- I. PUD2022-101 & EA2022-122 The Terraces at Queensgate South

**CITY OF RICHLAND DEVELOPMENT SERVICES DIVISION
STAFF REPORT TO THE HEARING EXAMINER**

PROPOSAL NAME: The Terraces at Queensgate South – Planned Unit Development

PROJECT TYPE: Type 3A Preliminary Planned Unit Development

PP02

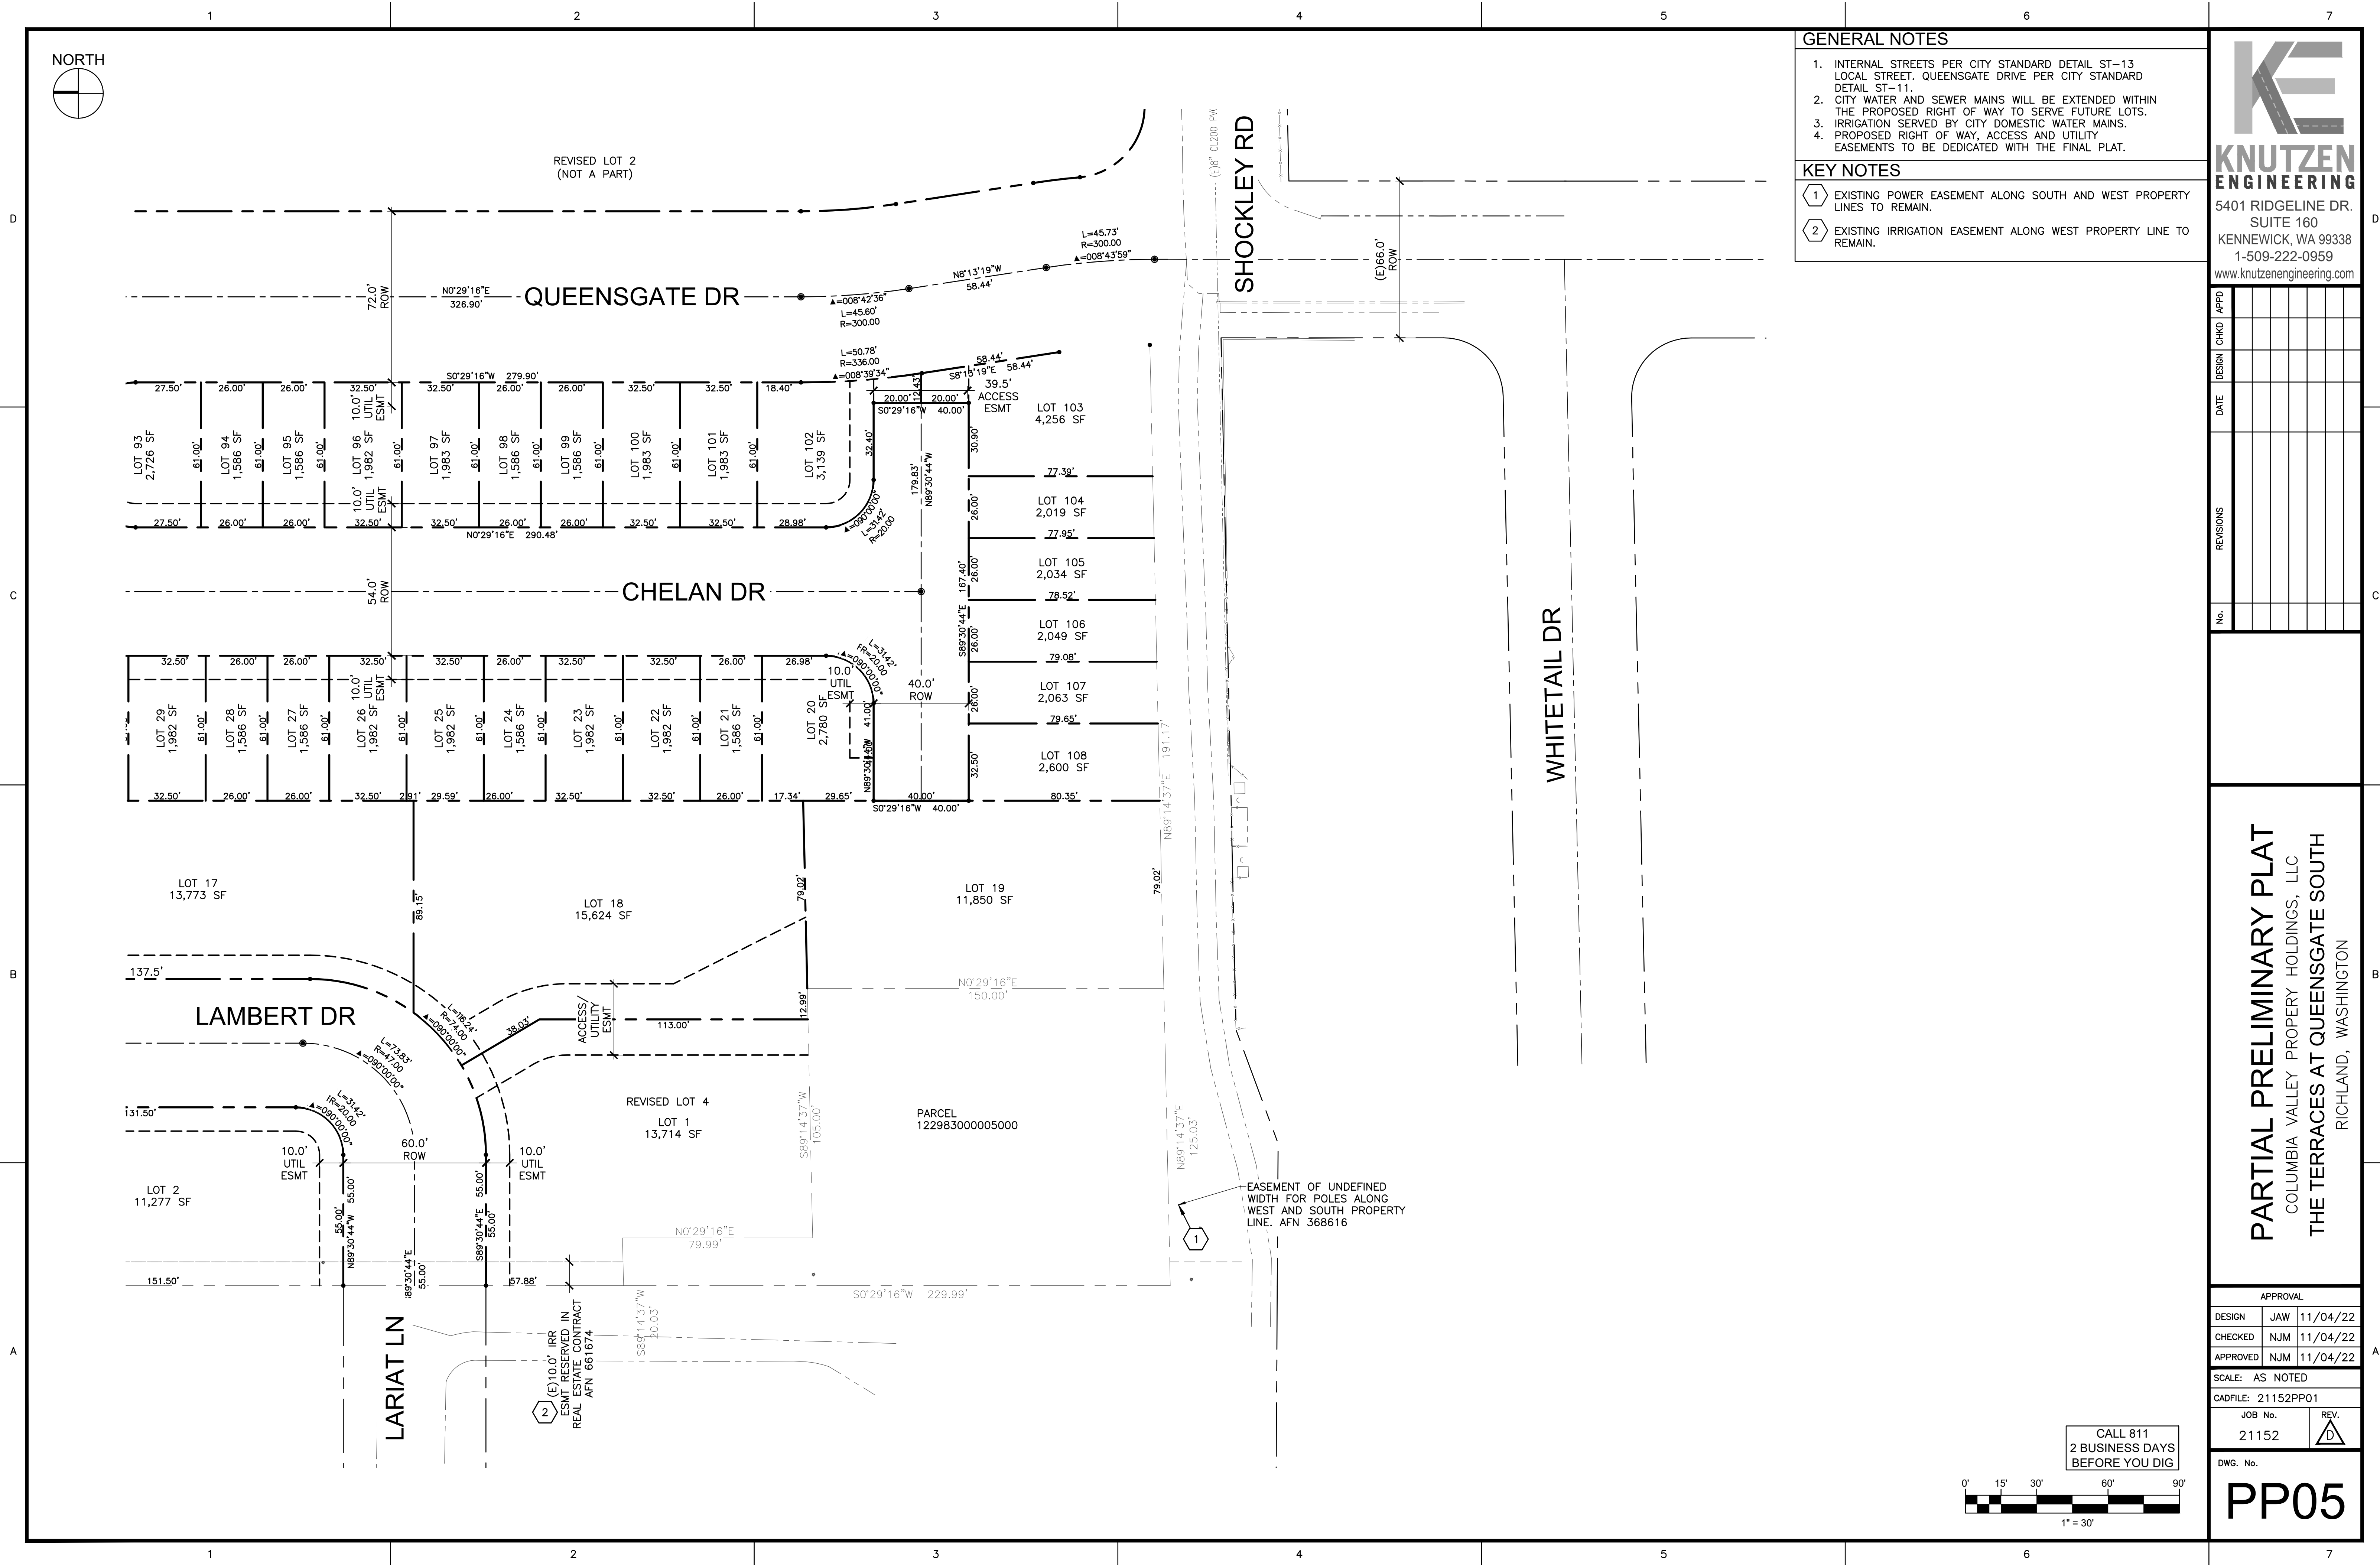
1. The limits (boundary) of this phase are not clearly depicted on the pre-plat map and need to be. Please provide a clear border of Phase 1.

22. The “Lambert Drive” right-of-way can be narrowed to 54-feet and does not have to be 60-feet wide as shown on sheet PP05.
23. Per city standard details, a 5-foot-wide separated asphalt pedestrian pathway shall be provided adjacent to all rural section roadways.

26. The centerline radius of “Lambert” Drive is depicted as 47-feet (Sheet PP05 of the pre-plat). This needs correction as per Richland Municipal Code the minimum centerline radius for a local street is 100-feet. Alternatively, the applicant can construct a city standard “Local Street Right Angle Intersection” at this curve.
